How to modify WS-PoE-Tester for 802.3af mode B and uPoE

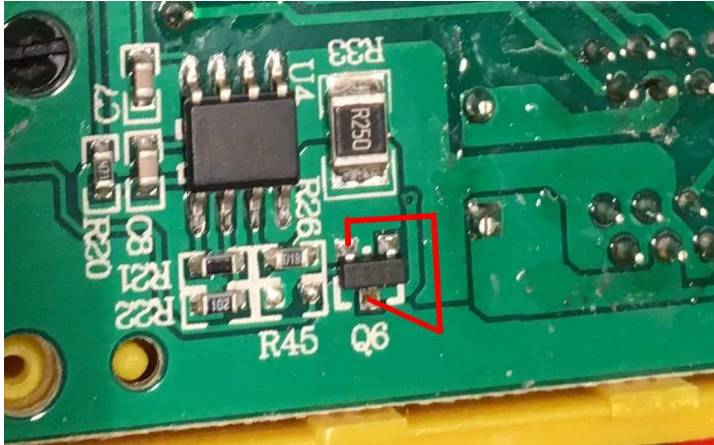
Solder a jumper to bypass Q6

Mode B jumper as shipped

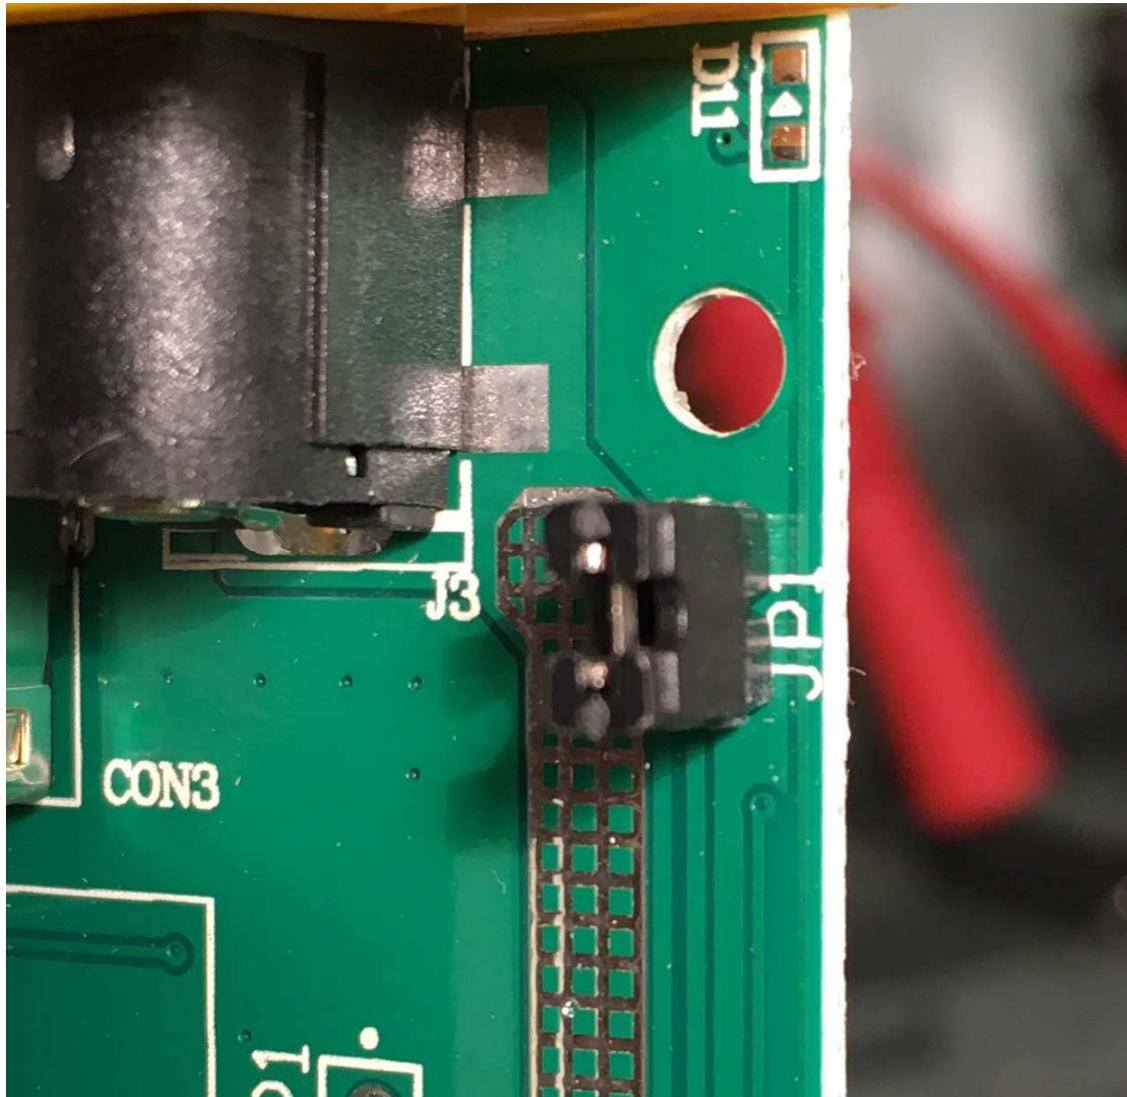
Remove jumper
